**Sacramento Employment and Training Agency (SETA)
Children and Family Services Department
Warehouse/Workshop/Office Space RFP
Offeror's Telephone Conference Call
June 17, 2020
Questions and Responses**

FLOOR PLAN

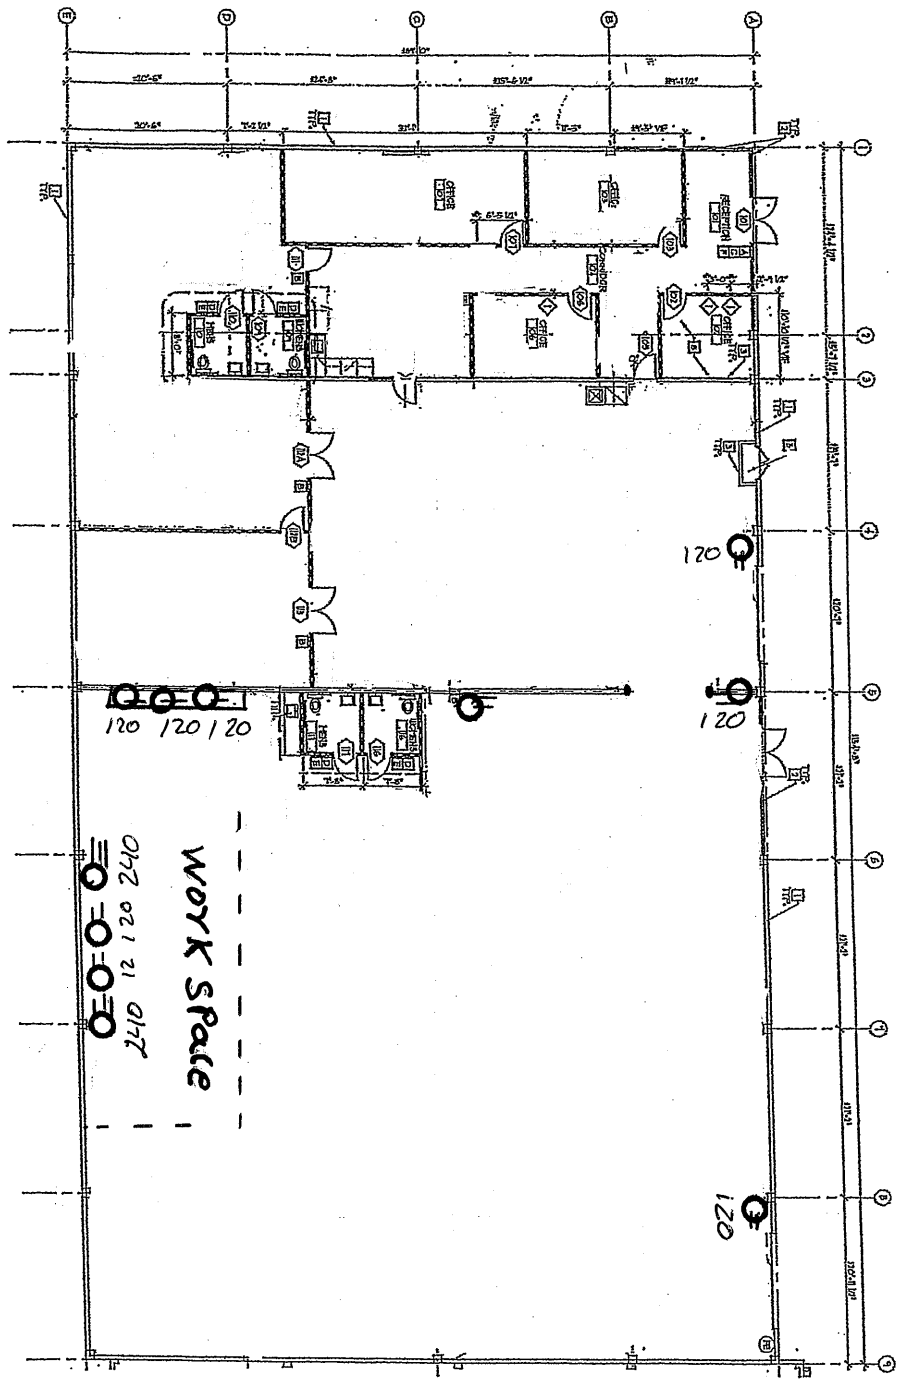
Question #19: Are there any expectations for electrical distribution in the shop?

Response: Standard 110v is used in most of the areas with exception of one 220v needed in the workshop for the table saw and dust collector equipment. Staff will get floor plan to show electrical outlets, 110v and 220v areas.
